802.3cy D0.5 FEC Related Comments

March 8, 2022

Introduction

Page 89 Line 9-15 Figure 165-6

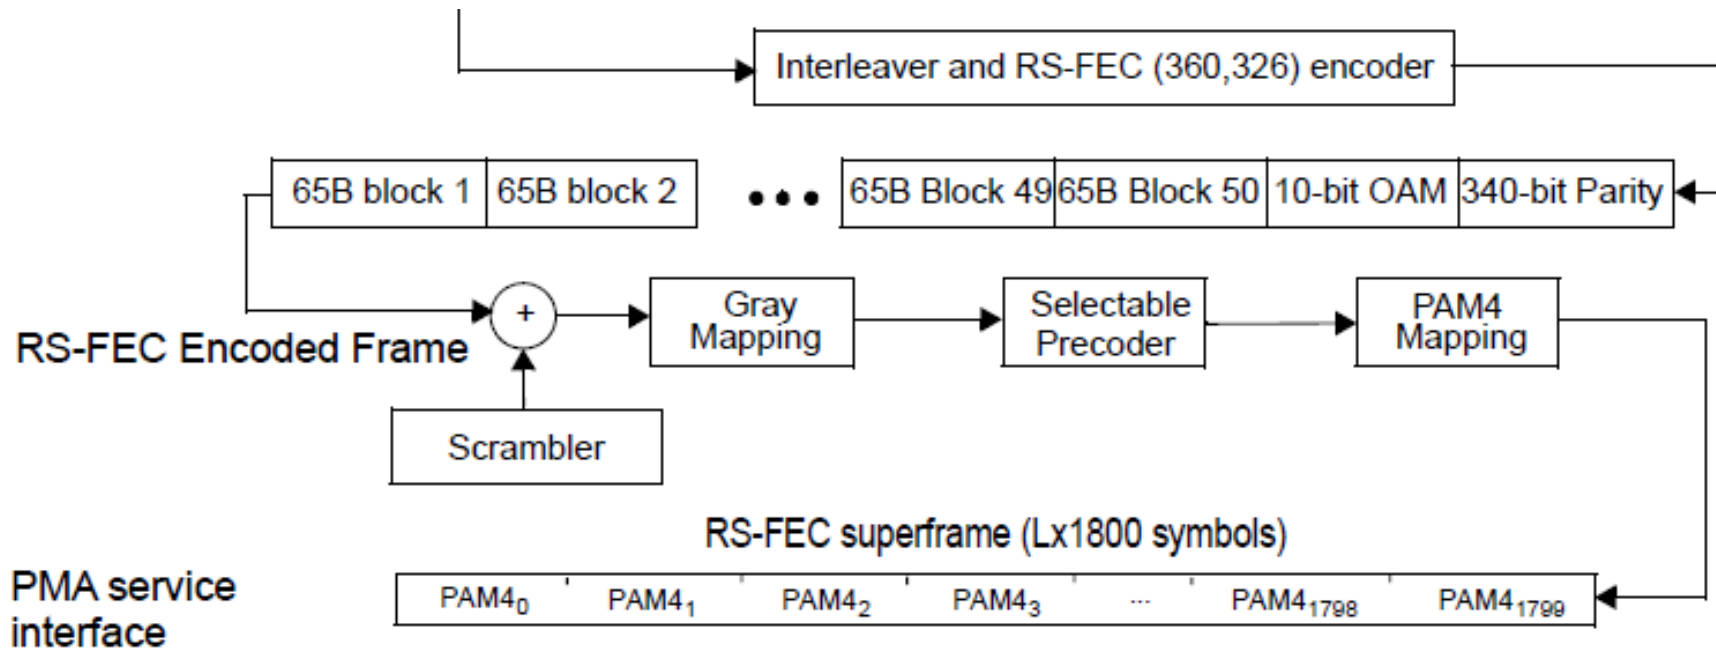
1. Change "50x 65B" to "130x 65B"
2. Change "65B Block 49" to "65B Block 129"
3. Change "65B Block 50" to "65B Block 130"

Page 89 Line 17-28 Figure 165-6

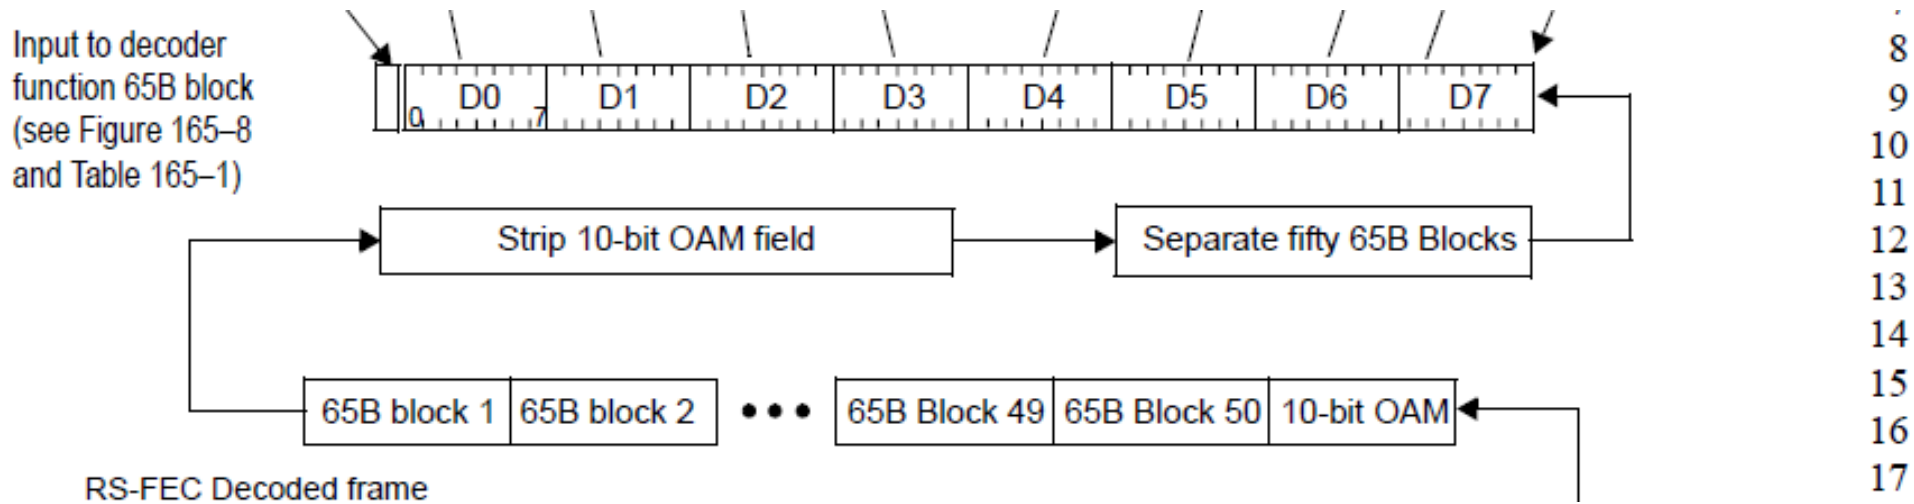
1. Change “RS-FEC (360,326)” to “RS-FEC (936,846)”
2. Change “65B Block 49” to “65B Block 129”
3. Change “65B Block 50” to “65B Block 130”
4. Change “340-bit Parity” to “900-bit Parity”
5. Change “Lx1800” to “Lx4680”
6. Change “PAM4₁₇₉₈” to “PAM4₄₆₇₈”, and “PAM4₁₇₉₉” to “PAM4₄₆₇₉”

Page 90 Line 8-17 Figure 165-7

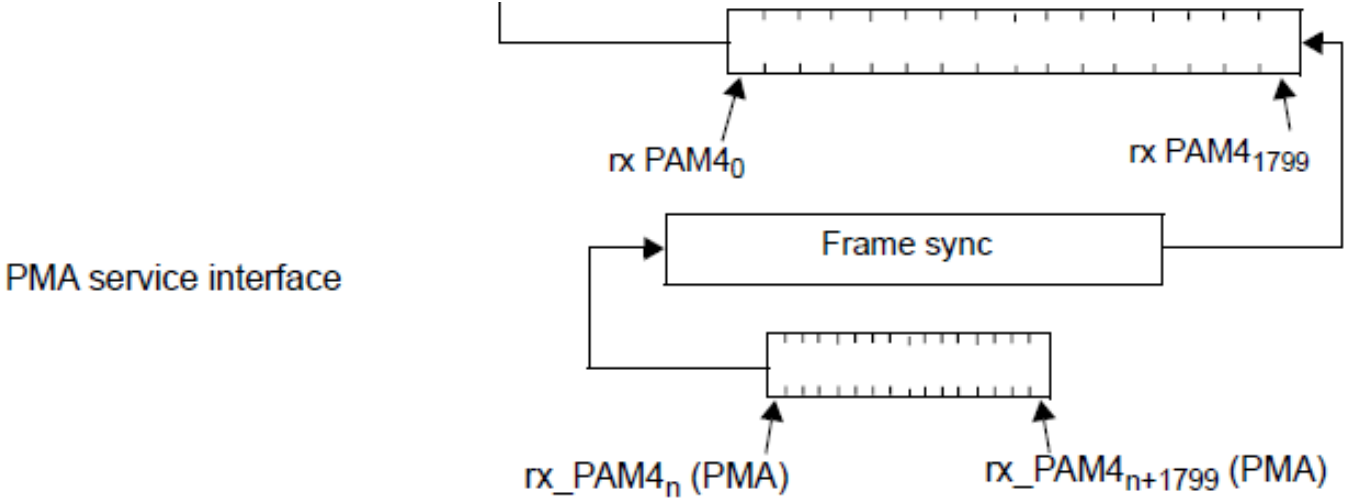
1. Change “Separate fifty 65B Blocks” to “Separate 130x 65B Blocks”
2. Change “65B Block 49” to “65B Block 129”
3. Change “65B Block 50” to “65B Block 130”

Page 95 Line 6-7 Figure 165-9

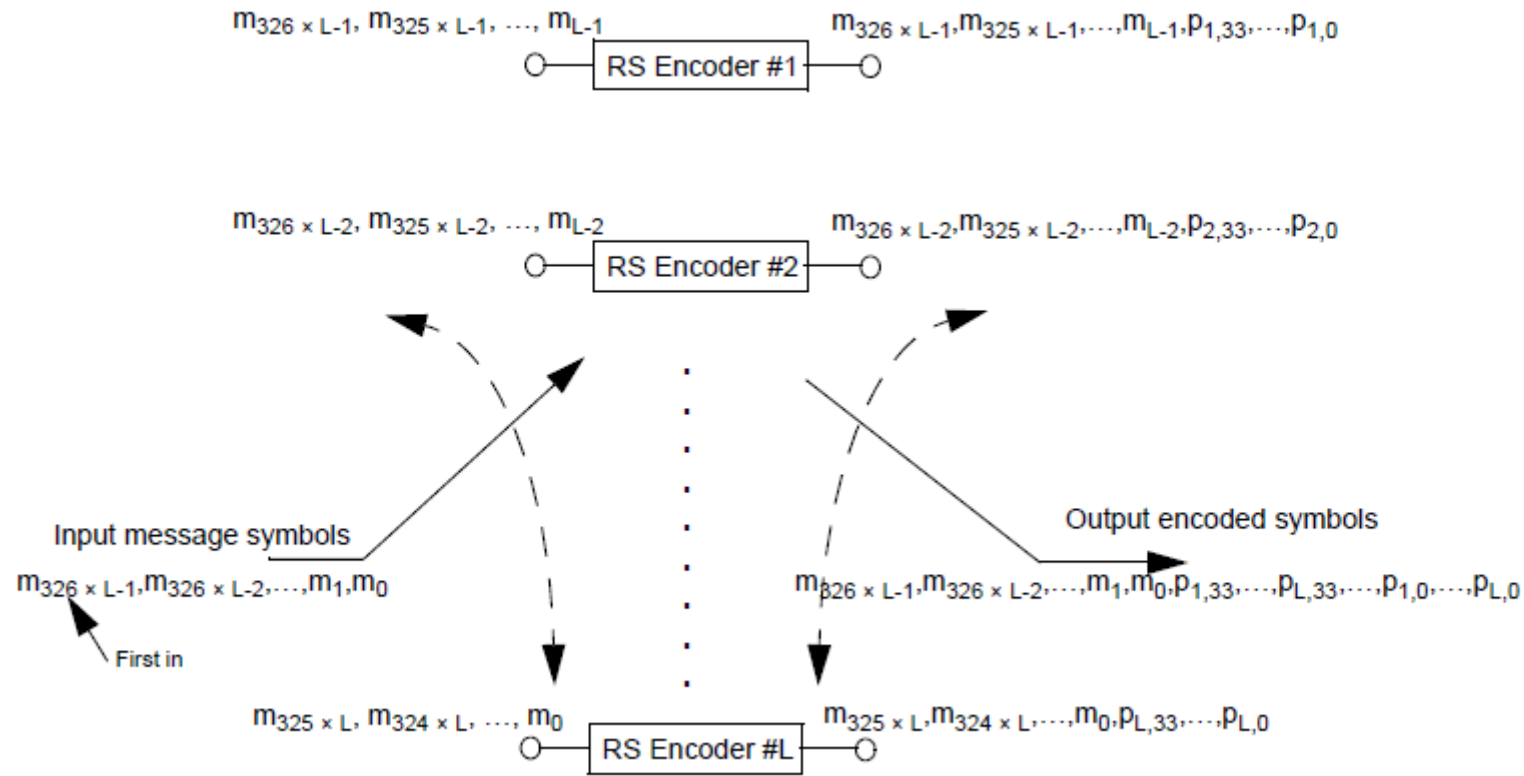
- Change “ $m_{326 \times L-1}$ ” to “ $m_{846 \times L-1}$ ”
- Change “ $m_{326 \times L-2}$ ” to “ $m_{846 \times L-2}$ ”

- Change all “326” to “846”
- Change all “325” to “845”
- Change all “324” to “844”
- Change all “33” to “89”

Figure 165-10—Reed-Solomon encoder functional model

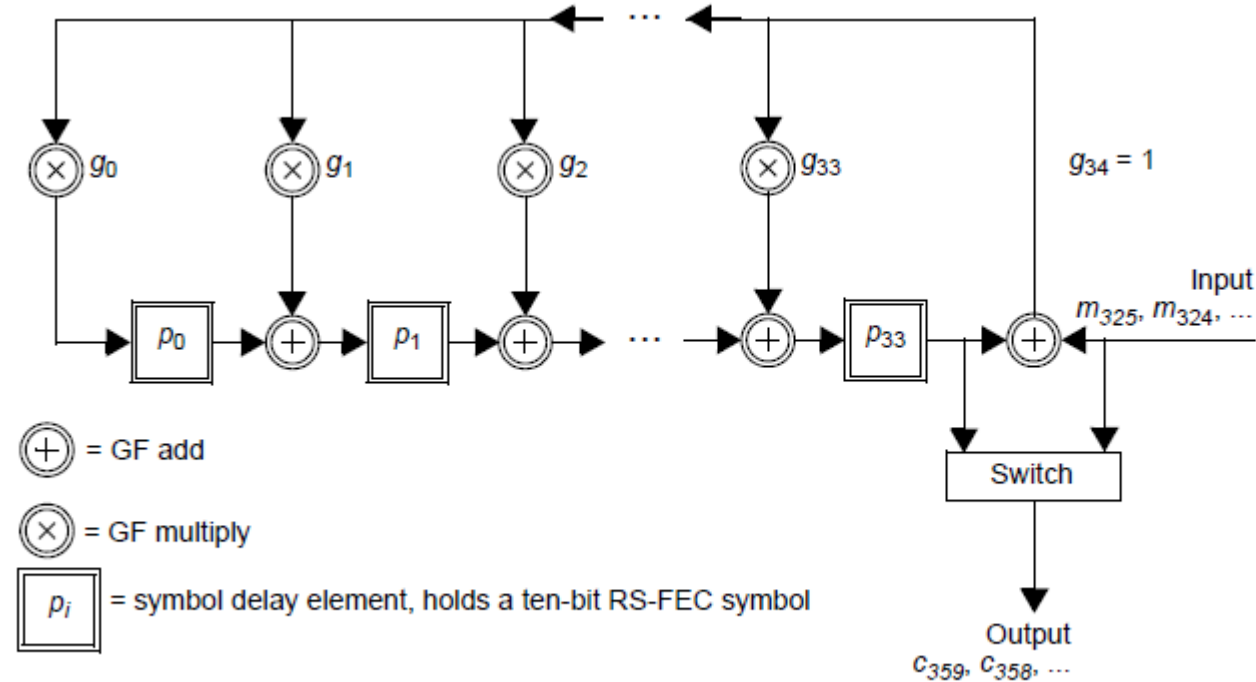
- Change all “33” to “89”
- Change “ $g_{34}=1$ ” to “ $g_{90}=1$ ”
- Change “ m_{325}, m_{324}, \dots ” to “ m_{845}, m_{844}, \dots ”
- Change “ c_{359}, c_{358}, \dots ” to “ c_{935}, c_{934}, \dots ”
